DALLAS WATER UTILITIES

BELTWOOD RESERVOIR EXPANSION

CONTRACT NO. 89-79

FINAL Plat
BELTWOOD RESERVOIR
AN Addition of The Town of Addison
-E. COOK SURVEY A-326
-E. FIKE SURVEY A-478

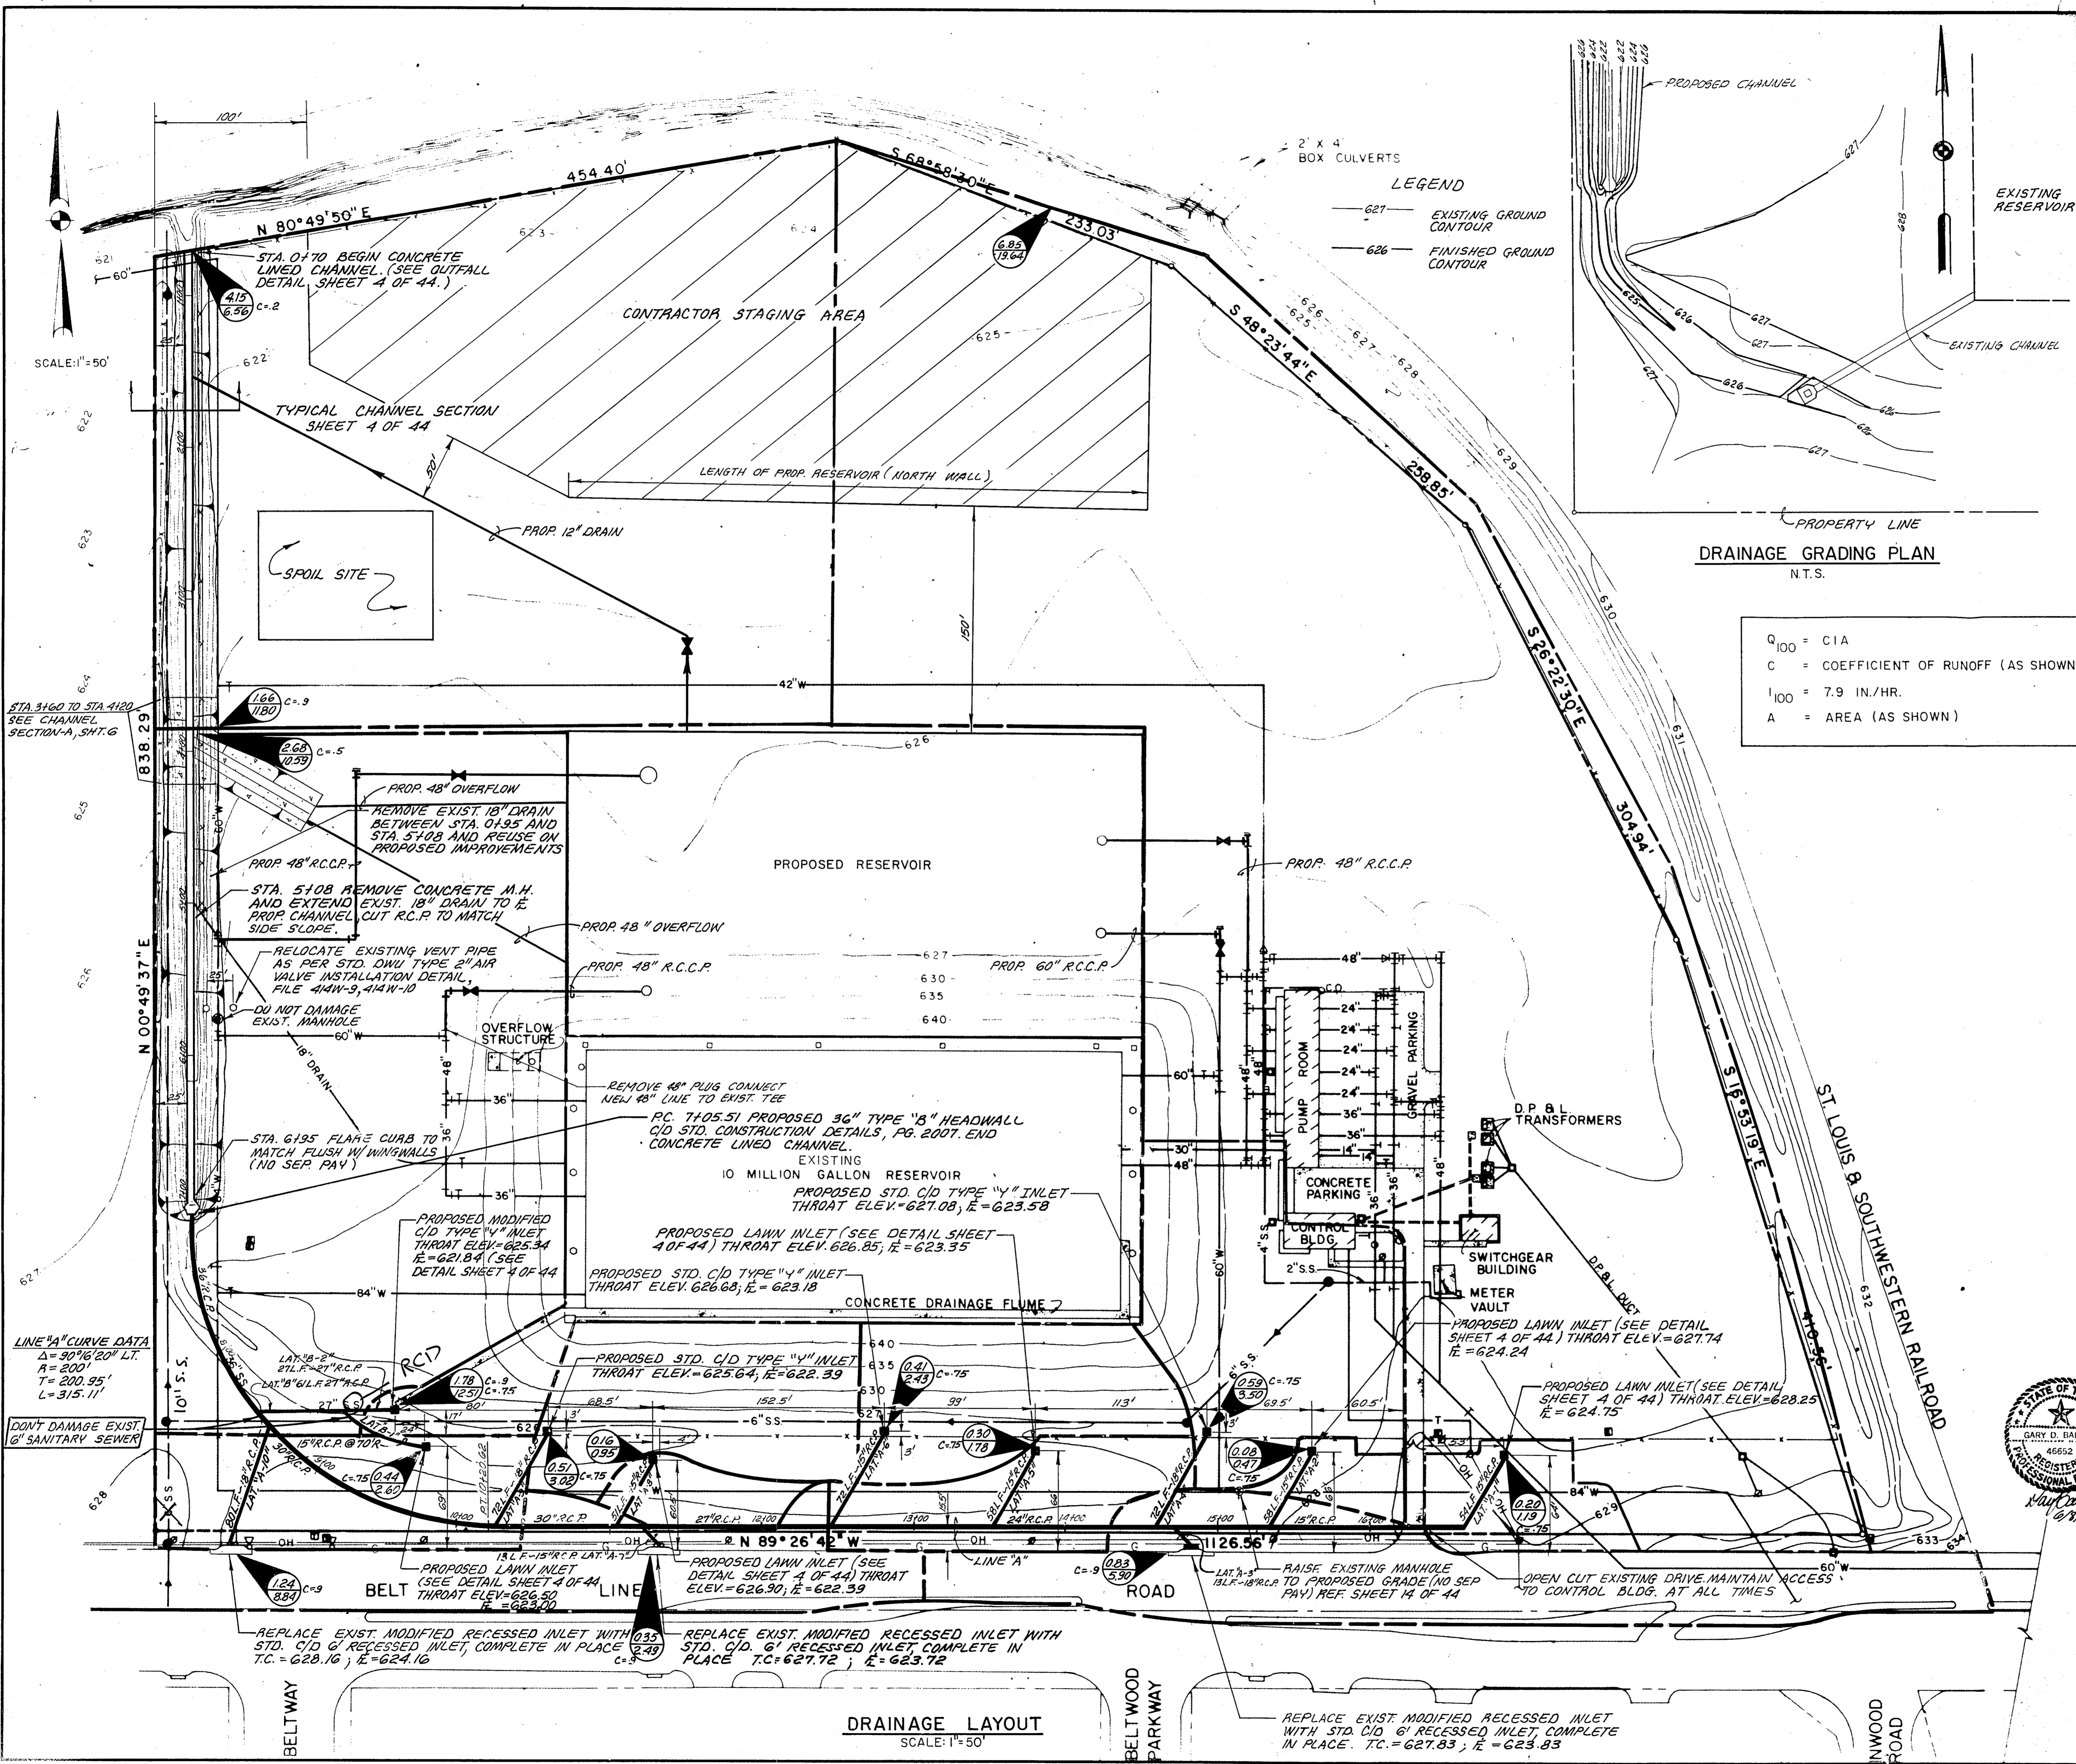
10.4 CALL OUT FND/SET/TYPE/SIZE
10.5 ON DRAWING AS
WELL AS DESCRIPTION

10.85 Statement as to origin of Bearing?
1. Geodetic
2. Tri-Corner
3. Record BEARING
10.10 Blow-ups of Corners Where There is a Difference From Survey

-ADDISON, DALLAS COUNTY, TEXAS
Date of Survey?
